SAFETY EVALUATION REPORT

Document Title: Oconee Nuclear Station Unit 3, Abnormal Transient  
Operating Guidelines (ATOG)

Document Date: March 23, 1982 with June 25, 1982 Updates

Originating Organization: Babcock and Wilcox Nuclear Power  
Generating Division

Figure 2 Operator actions regions for ICC

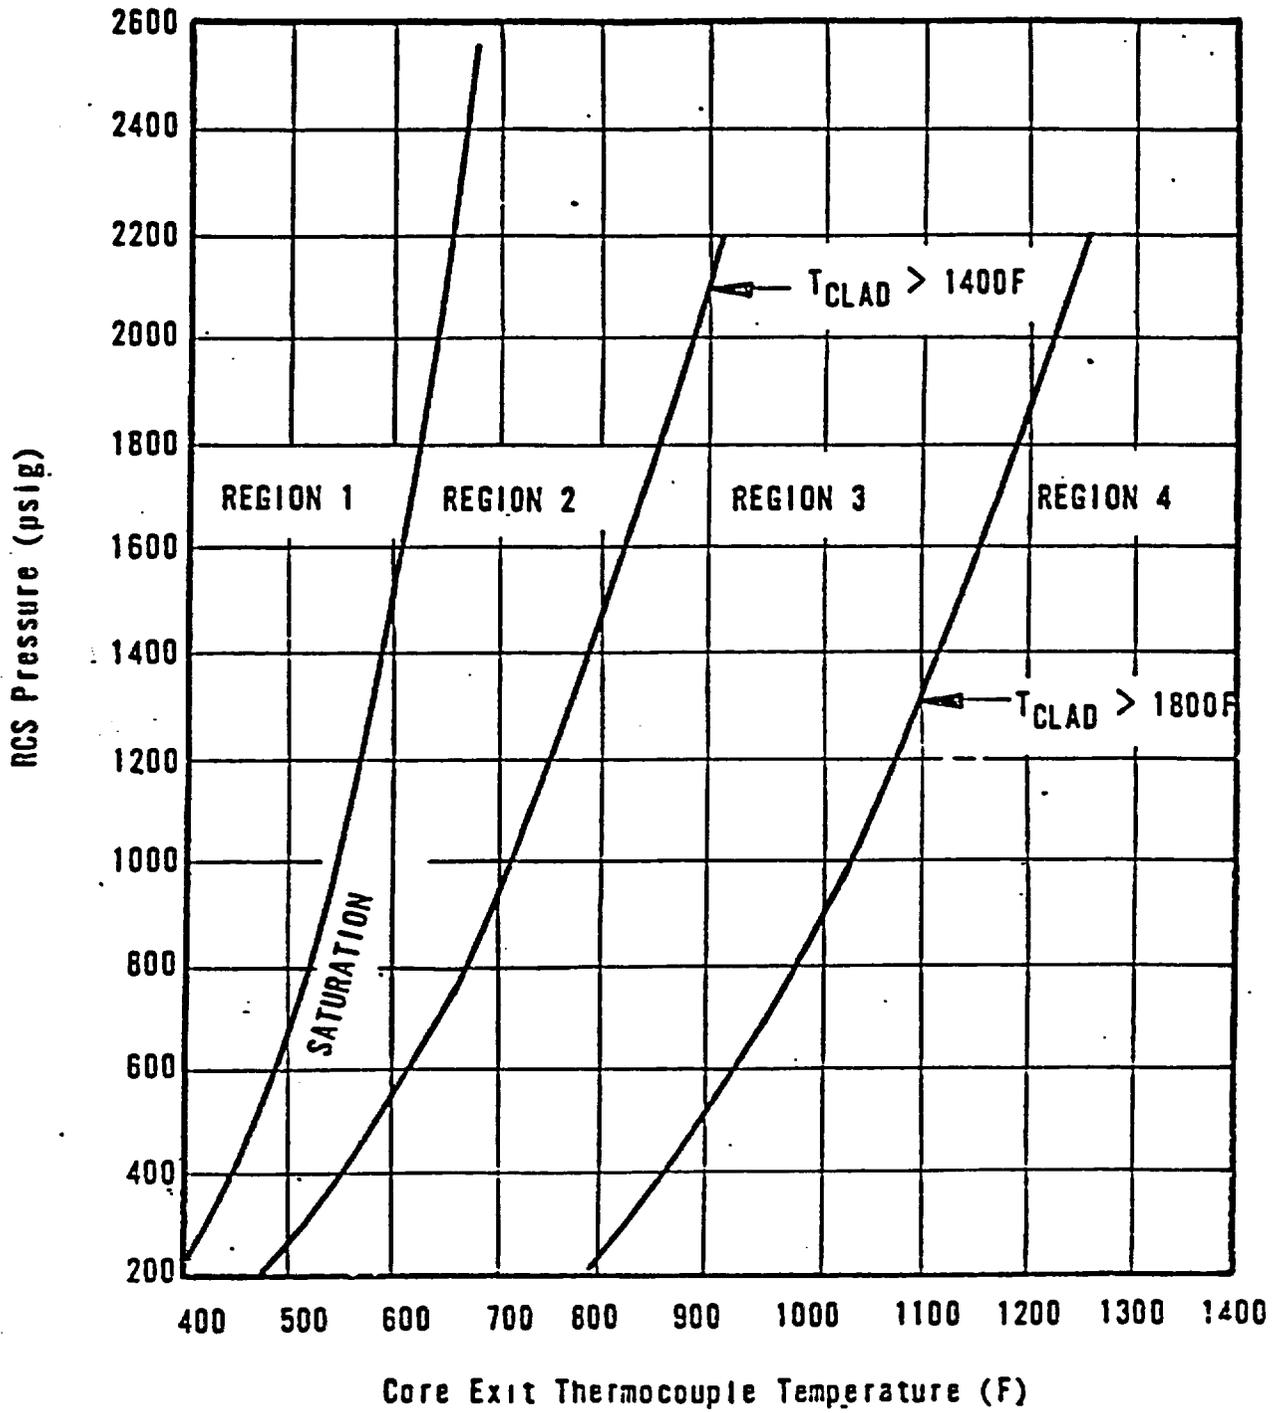
Areas in the ICC guidance which need improvement include:

- (1) Changes to the ICC Section should provide guidance on the use of reactor vessel level/inventory measurement systems becoming operational in B&W plants.
- (2) Additional analytical investigations are needed, as discussed in Section 3.13.

- (3) The Guidelines should provide operator guidance following potential core damage, such as clad degradation, with particular attention given to minimization of releases for such conditions as a SGTR and the use of steam release as a method for control of plant parameters.
- (4) Additional comments regarding RCP operation (Section 3.2.2), voiding (Section 3.4.2), and cooldown (Section 3.9.6) should be considered in providing ICC guidance.

Figure 3 P-T limit curves

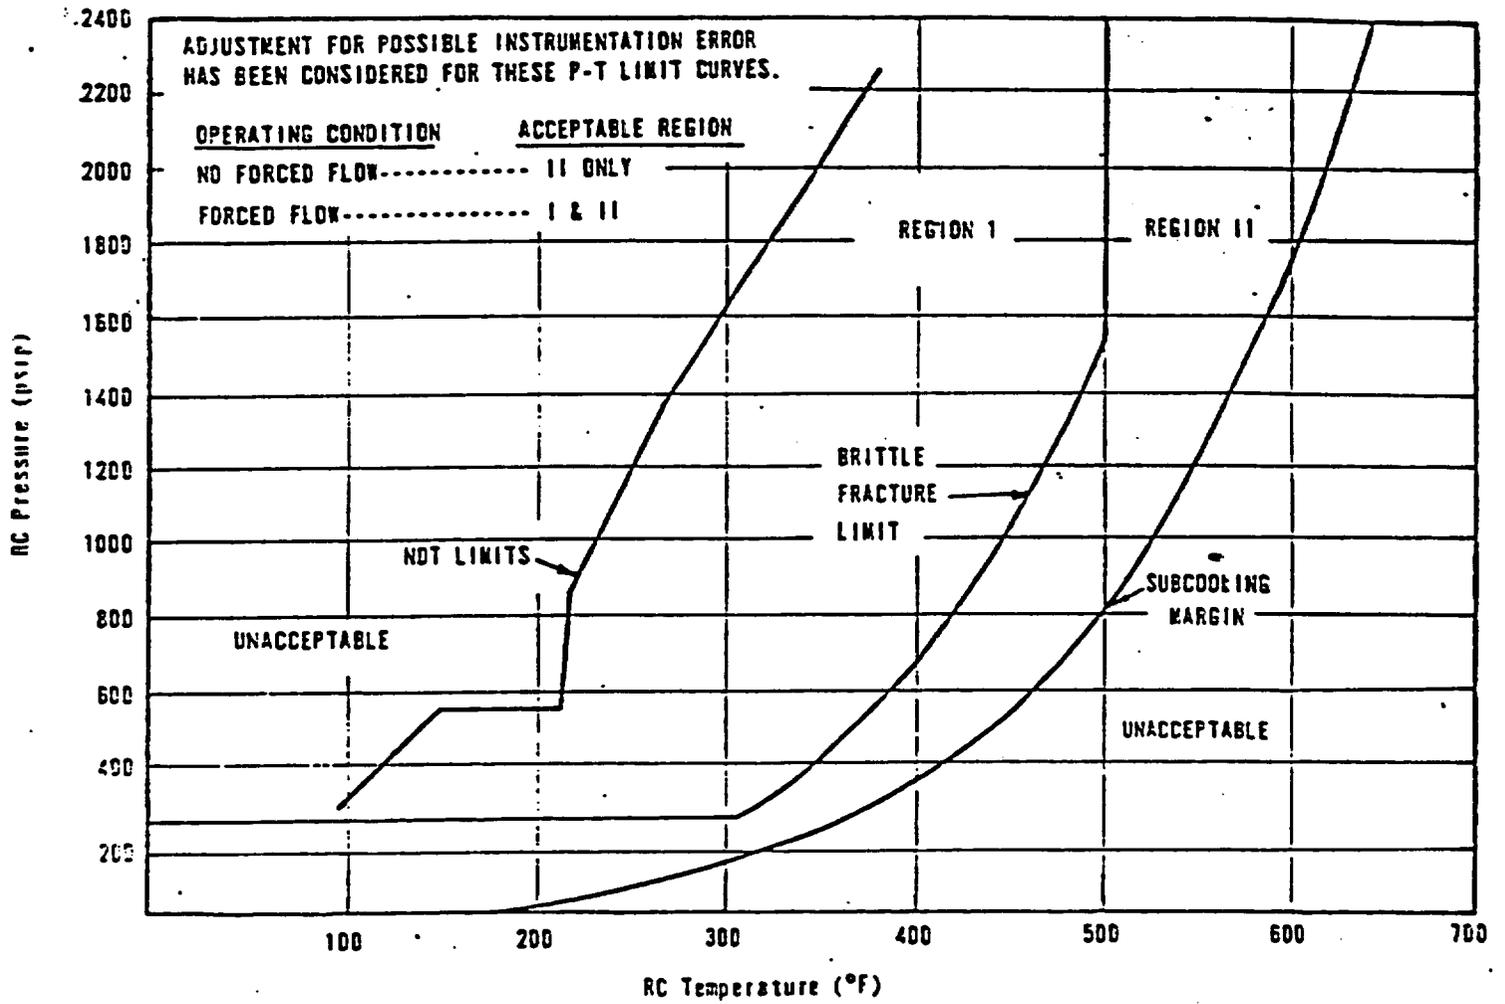
Guidance should be provided for the case where pressure-temperature limits, typified by Figure 3, have been exceeded.
